HYDROLOGICAL REPORT

7 August 2009

East Baldivis District Structure Plan – reconciliation of the preferred layout with District Water Management Strategies

OWNERSHIP BOUNDARIES - EAST BALDIVIS

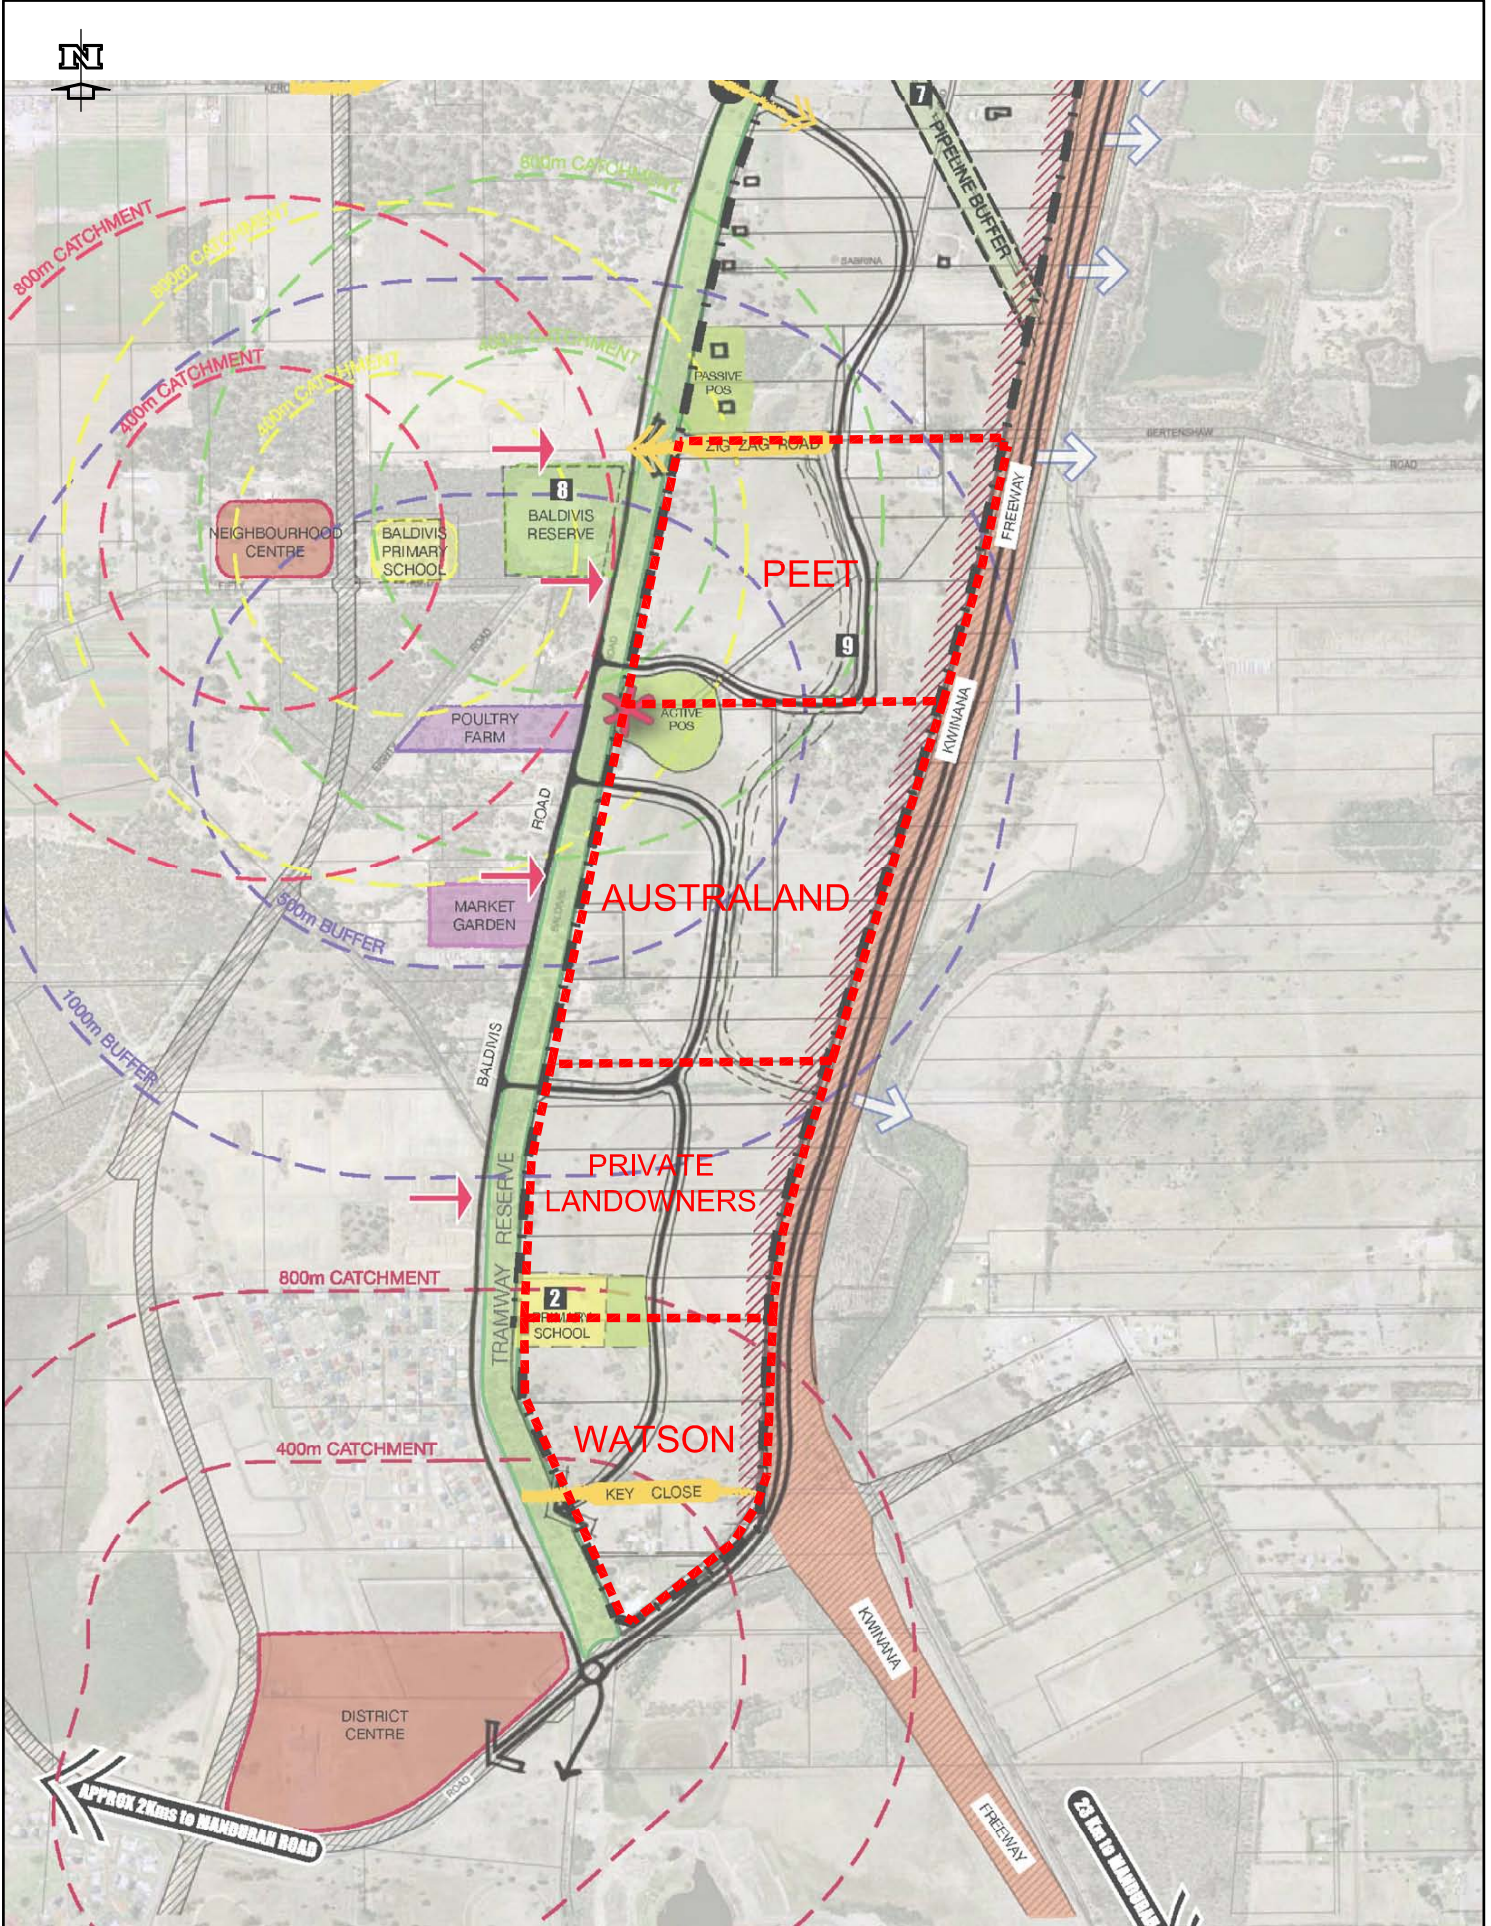
The table below summarises the 100year ARI storage requirements outlined in the DWMS – for both offline storage and central drainage swale in the multiple use corridor – along with the POS areas provided in the East Baldivis District Structure Plan Indicative Concept Plan. Figure 1 (attached) shows the landholding boundaries for the area south of ZigZag Road which have been adopted in the DWMS.

Landholding	Peet	Australand	Private	Watson	TOTAL
DWMS requirement - Area required for drainage [central swale + basin] (ha)	0.6 + 2.2	0.9 + 2.6	0.6 + 1.4	0.6 + 1.4	2.7 + 7.6
DSP provision - POS available for drainage – i.e. central corridor only (ha)	2.4	3.6	-	-	6.0
Shortfall in POS	0.4	-	2.0	2.0	4.4

The above table assumes that the active POS and primary school POS areas will not be utilised for drainage purposes. The 'active POS' area is located on the upstream side of the DSP which is inefficient for incorporating drainage. The primary school POS is not likely to be permitted to include a large proportion of drainage function, except for major storm events.

The provision of a ~40m wide central multiple-use/drainage corridor through the southern two landholdings (private landowners and Watson Property Group), similar to that shown through Peet and Australand's landholdings, will ensure compliance with the DWMS and provide sufficient POS for drainage management.

CATCHMENT BOUNDARIES - NORTH EAST BALDIVIS

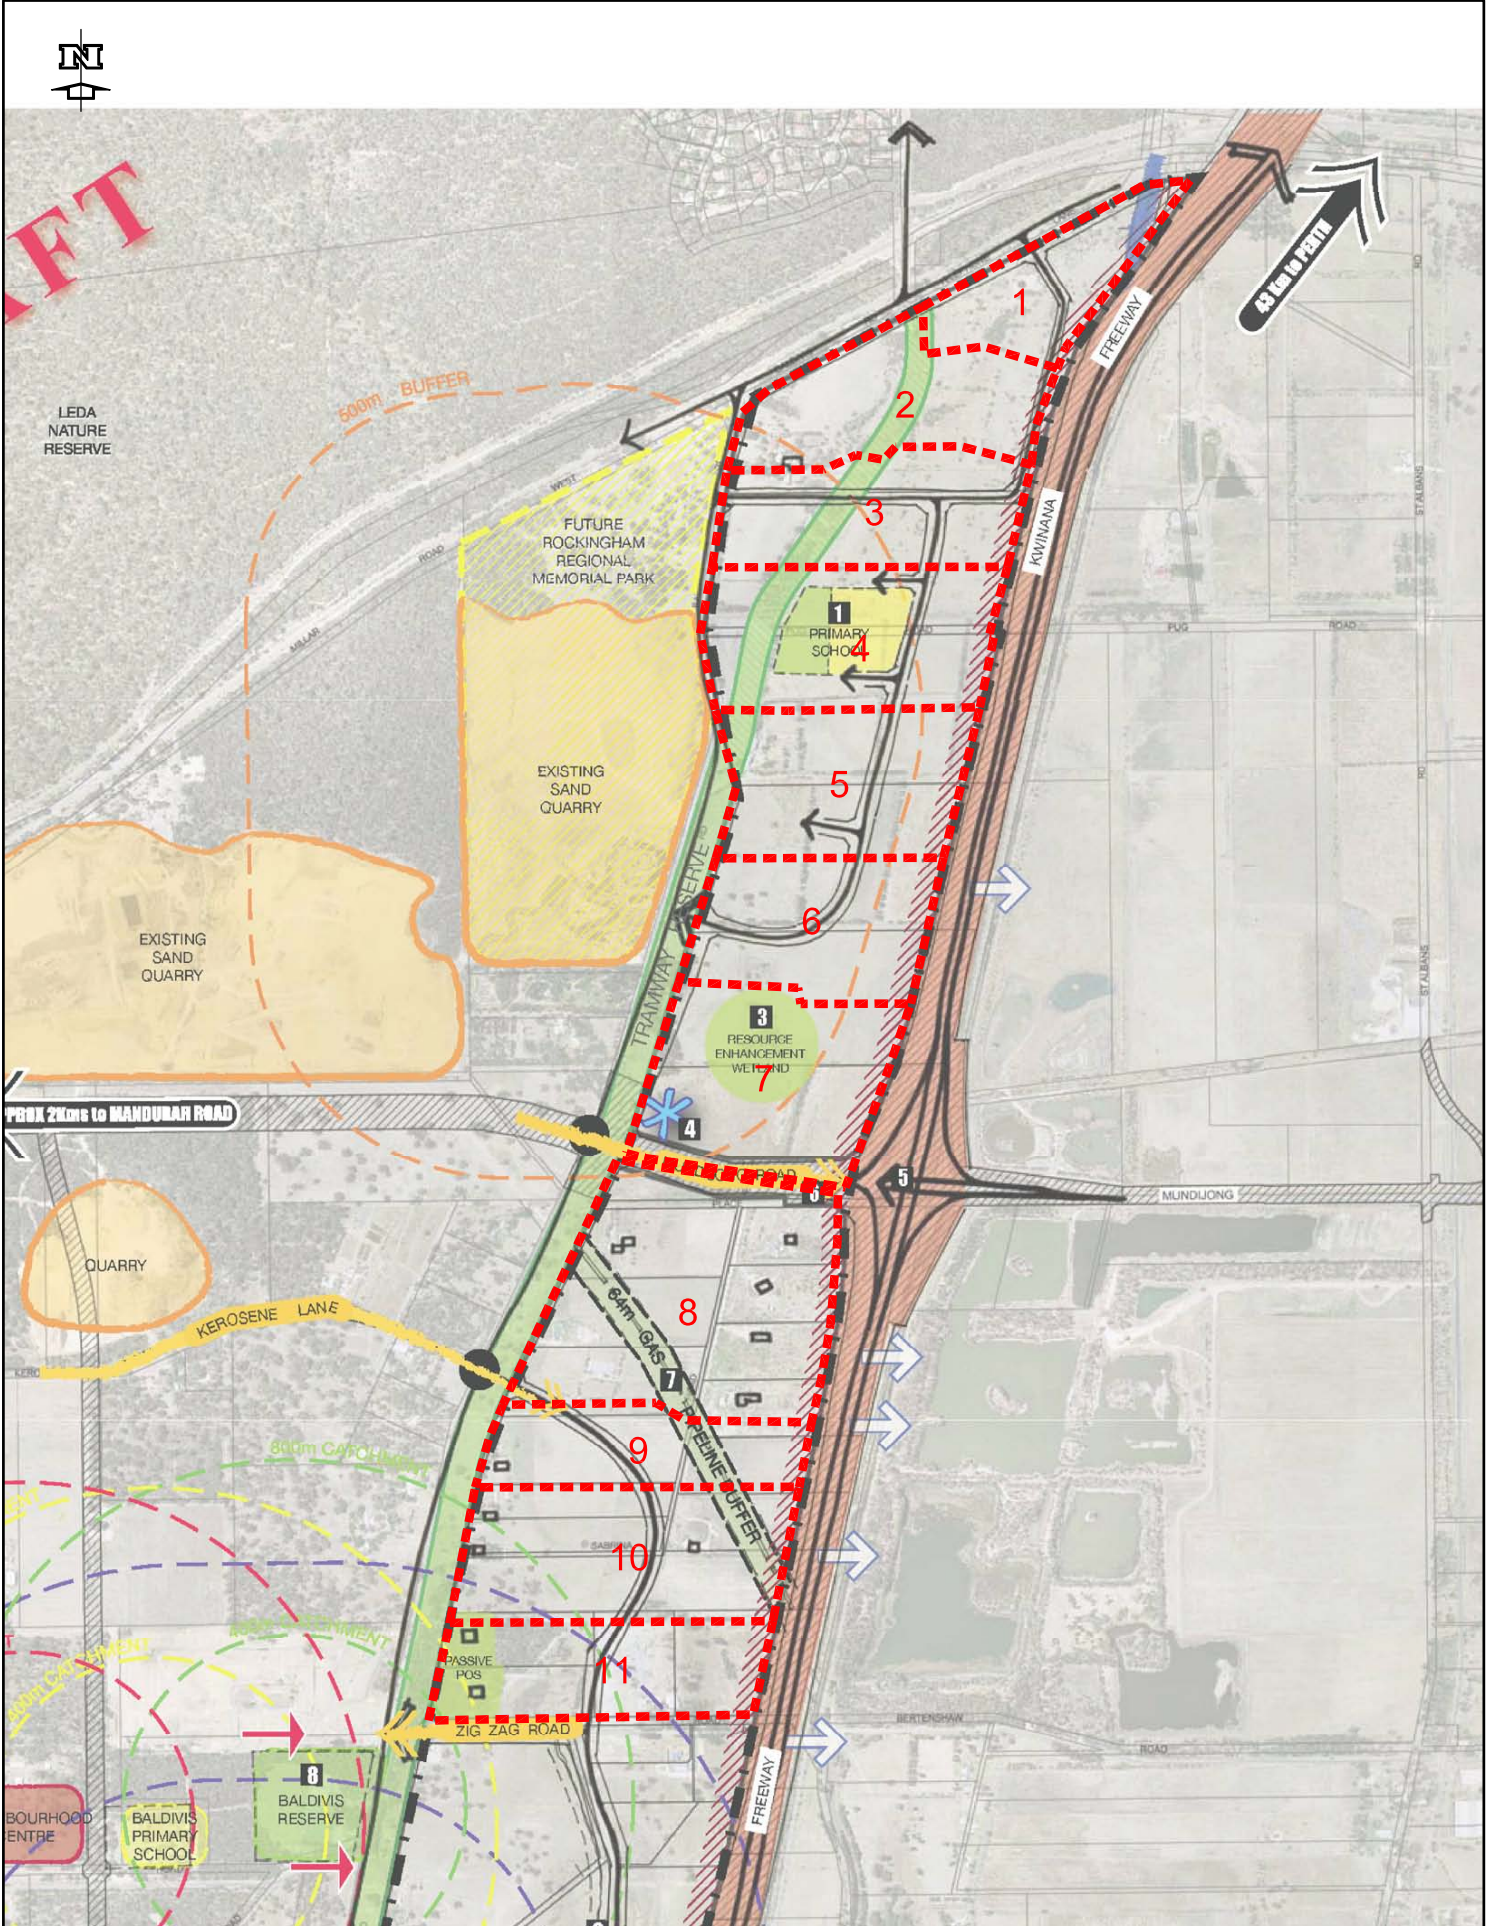
The table below summarises the 100year ARI storage requirements outlined in the DWMS along with the POS areas provided in the East Baldivis District Structure Plan Indicative Concept Plan. Figure 2 (attached) shows the subcatchment boundaries assumed in the DWMS.

Subcatchment	1	2	3	4	5	6	7	8	9	10	11	TOTAL
DWMS requirement - Storage basin area (ha)	0.9	1.2	1.3	1.5	1.2	1.2	1.4	2.2	1.0	1.7	1.3	14.9
DSP provision - POS available for drainage (ha)	-	-	-	-	-	-	4.9	-	-	-	-	4.9
Shortfall in POS	0.9	1.2	1.3	1.5	1.2	1.2	-	2.2	1.0	1.7	1.3	13.5

The above table assumes that the passive POS and primary school POS areas will not be utilised for drainage purposes, as they are both located on the upstream side of the DSP which is inefficient for incorporating drainage. The primary school POS is also not likely to be permitted to include a large proportion of drainage function, except for major storm events.

The above table assumes that the Resource Enhancement Wetland shown on the Indicative Concept Plan will be permitted to be used as a drainage attenuation area, and that all drainage from subcatchment 7 will be incorporated into the REW area.

Efficiencies to reduce the required storage areas may be achieved by designing the drainage system in a similar manner to the landholdings south of ZigZag Road, with a central drainage corridor to convey flows and smaller offline storage areas in each subcatchment. Furthermore, it is recommended to complete pre-development modelling to determine peak flow rates, rather than assuming an overall 'per-hectare' allowable flow rate.
